16/32-BIT MICROCONTROLLER
MB9FXXX

HANDLING NOTE
DATA POLLING FLAG DURING FLASH
SECTOR ERASE

2009-05-25

Figure 1: Operation of DQ7 and DQ3

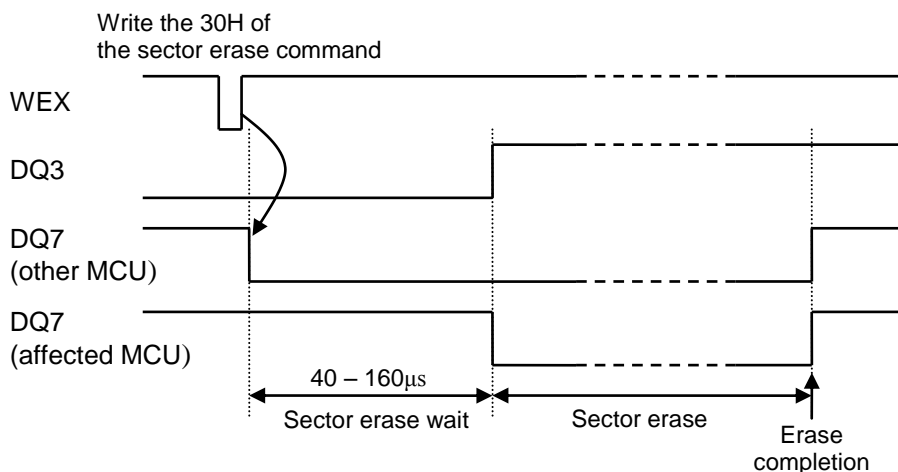
During this ‘sector erase wait’ state, the data polling flag DQ7 outputs ‘1’ in affected MCUs. DQ7 changes to “0” with entering the actual erase state.

For other MCUs, this behaviour is different: DQ7 outputs ‘0’ already in ‘sector erase wait’ state.

This behaviour of the DQ7 flag is not described correctly or precisely in all hardware manuals. If the software only polls the DQ7 flag to detect the ‘erase completion’, then the software could misinterpret the ‘sector erase wait’ state as ‘erase completion’ in affected MCUs, although such software works correctly in other MCUs.

Figure 2: Workaround by DQ6

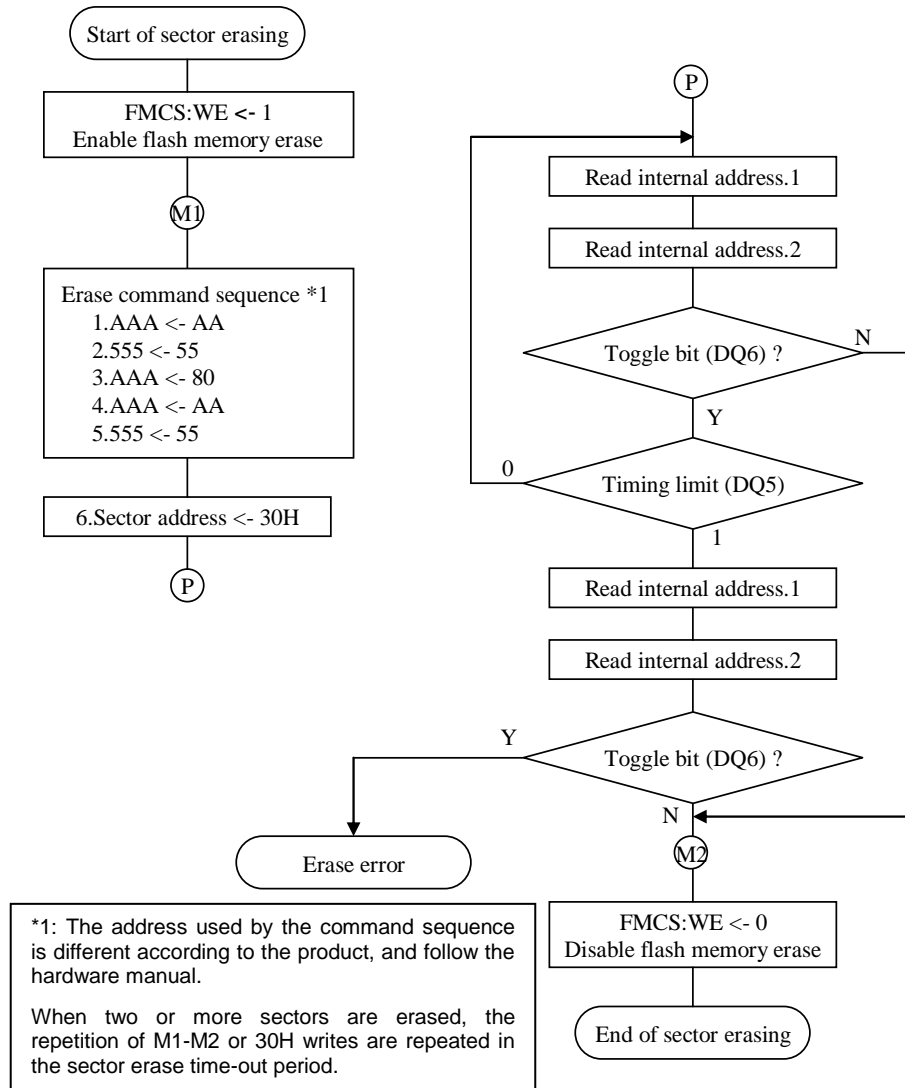
Please judge the state of an automatic algorithm by using DQ6 as shown in the figure below.

Figure 3: Workaround by DQ3

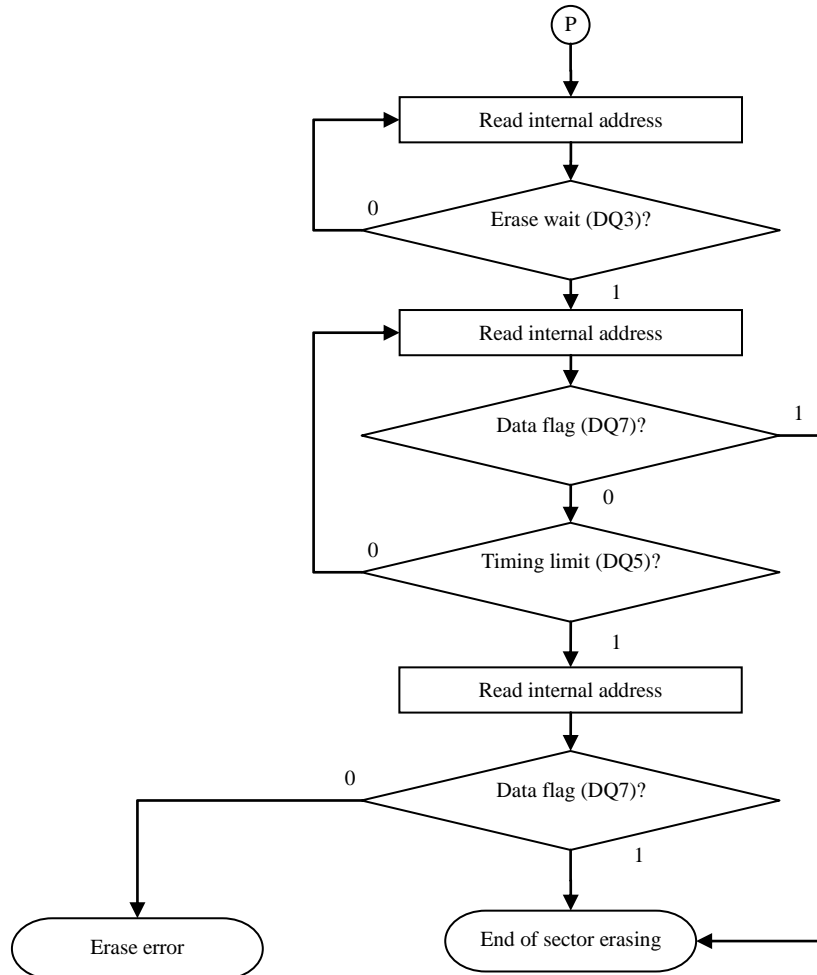
As shown in the timing chart of Figure 1, start the polling of DQ7 after waiting for 160us or more with software after the command is issued or waiting for DQ3 = 1 (end of the sector erase time-out period).

Please judge the state of an automatic algorithm by using DQ3 as shown in the figure below.

Figure 4: Workaround by Data Polling

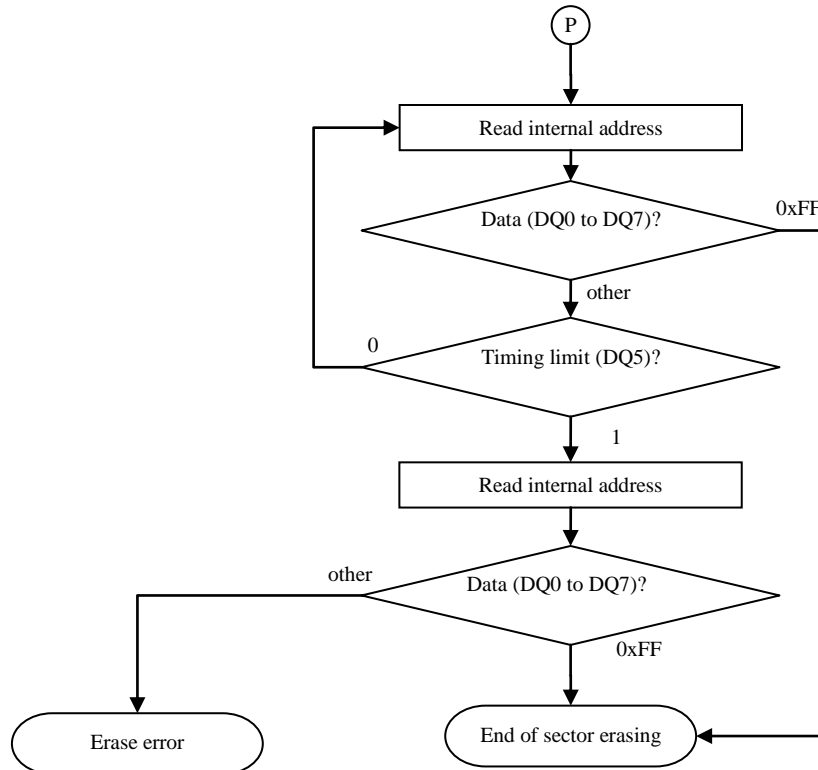
Instead of polling only the DQ7 flag, all 8 data bits can be checked for equality to 1.

Please judge the state of an automatic algorithm by using data polling as shown in the figure below.
